Access Compliance Report

Public Rights-of-Way

Intersection ID: 28367	Main Street: SOUTHAMPTON COMMONS DR	Cross Street: TRAVIS GULCH DR	Location: NW
ADA ID: DC21E56D22D4	Ramp Type: PerpDiag	Initial Pass/Fail: Pass	Overall Compliance: No
Severity Score: 17.75			
Codes/Mitigation Info/Possible Solution		Field Measurements/Component Compliance

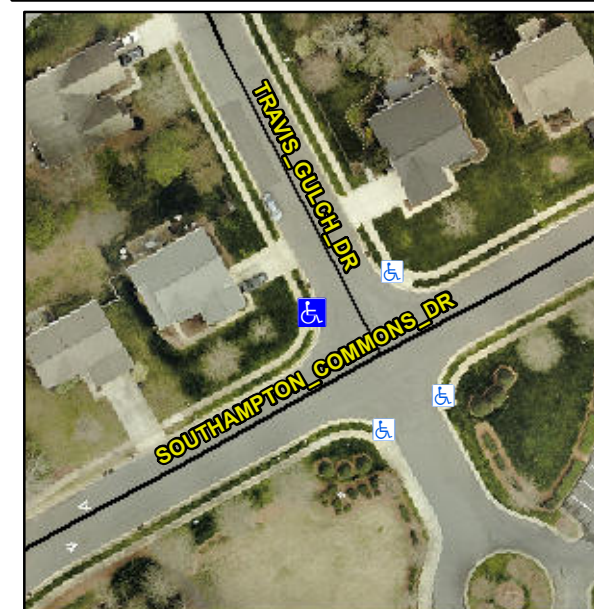
Not Found, R304.5.3, R305, R302.7.2

Compliance	Description	Data	Compliance	Description	Data
N/A	Ramp Length (in)	45.0	Yes	Ramp Slope (%)	7.5
Yes	Ramp Width (in)	48.0	No	Ramp XSlope (%)	3.2
N/A	Flare Type LT	Sloped	N/A	Flare Type RT	N/A
N/A	Flare Slope LT (%)	6.4	Yes	Flare Slope RT (%)	6.6
N/A	Flare Traversable LT?	Yes	N/A	Flare Traversable RT?	Yes
Yes	Landing Length (in)	48.0	No	DWS Provided?	No
Yes	Landing Width (in)	48.0	N/A	DWS Contrast?	No
Yes	Landing Slope (%)	1.9	N/A	DWS Length (in)	N/A
Yes	Landing X Slope (%)	1.0	N/A	DWS Full Width?	No
N/A	Landing Curb? (Y/N)	No	N/A	DWS Offset (in)	N/A
N/A	Shared Landing?	No			
Yes	Gutter Ponding?	No	Yes	Gutter Slope (%)	3.6
No	Gutter Lip Ht (in)	0.5	Yes	Gutter X Slope (%)	1.5
N/A	Painted X Walk1?	No	N/A	Painted X Walk2?	No
	X Walk 1 Direction	To S		X Walk 2 Direction	To E
N/A	X Walk 1 Width (in)	N/A	N/A	X Walk 2 Width (in)	N/A
	X Walk 1 Slope (%)	0.1		X Walk 2 Slope (%)	2.8
	X Walk 1 X Slope (%)	1.6		X Walk 2 X Slope (%)	0.6

Remove & Replace Curb Ramp With Two New Directional Ramps or Equivalent.
